21 July 2023

**Submission – Draft Amendment LPS2022003, Central Coast Local Provisions Schedule (LPS)
and Permit DA2022107 – 6 Johnsons Beach Road, Penguin**

Intersection between Johnsons Beach Road and Main Road

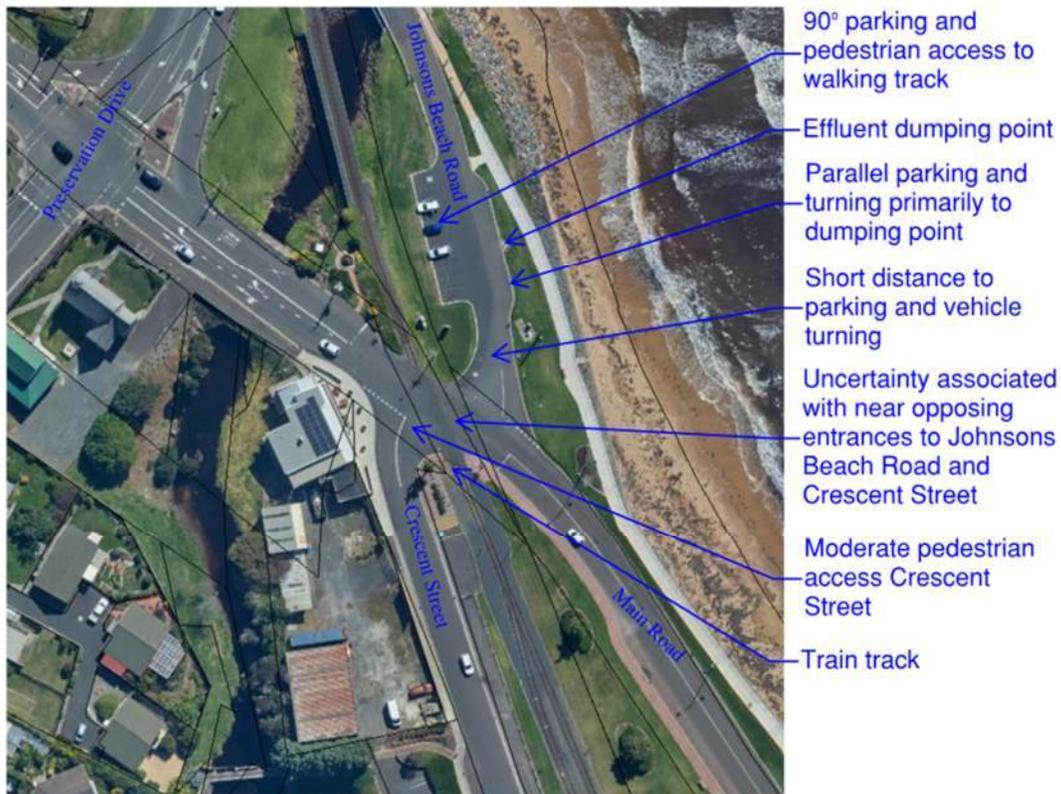
The intersection between Johnsons Beach Road and Main Road is problematic and modifications to the intersection should be included to mitigate the adverse effect of additional vehicle movements. The area is shown on the following image taken from www.thelist.tas.gov.au (the List) with markups.

In the following image a number of the existing features that make this intersection problematic are identified including the fact that there are 2 x T intersections in close proximity on opposing sides to Main Road and there are features Johnsons Beach Road that cause congestion near the intersection raising safety concerns with the intersection.

- The assessment of sight distance did not consider or comment on the site distance to the traffic from Crescent Street. This seems to have been the source of one of the accidents at the intersection in the past.

- The report does not consider or comment on the impact of additional traffic movements at the intersection where there is a distance of approximately 20m where parked vehicles are reversing (potentially) into traffic turning into Johnsons Beach Road. Likewise, the report does not consider or comment on caravans and other larger vehicles turning at that carpark to access the effluent dump on the opposite side of the road. Also, the report does not consider or comment on pedestrians crossing Johnsons Beach Road to access the walking track.

- The report does not consider or comment on the potential for bus movements associated with the proposed development. With this number of units to be developed there is a possibility /

probability that the accommodation may be serviced by tour buses. Having buses entering and exiting from Johnsons Beach Road would be a significant change in the current use where it is plausible and foreseeable that a bus may be caught on the railway line where there is congestion within Johnsons Beach Road. The provision of buses is likely to adversely impact on the proposed modifications to the intersection in the Master Plan as shown (extracted) below. The provision of tree planting as illustrated may also make visibility of congestion in Johnsons Beach Road more difficult.

In this submission it is concluded that there has not been sufficient consideration for this intersection in the proposal and that the reference to sight distances is not a sufficient assessment of the existing arrangement. This is a complex intersection where there is a history of accidents and concern about pedestrian safety. There is an increase in vehicle movement proposed that may include buses and this is likely to make an already poor intersection worse.
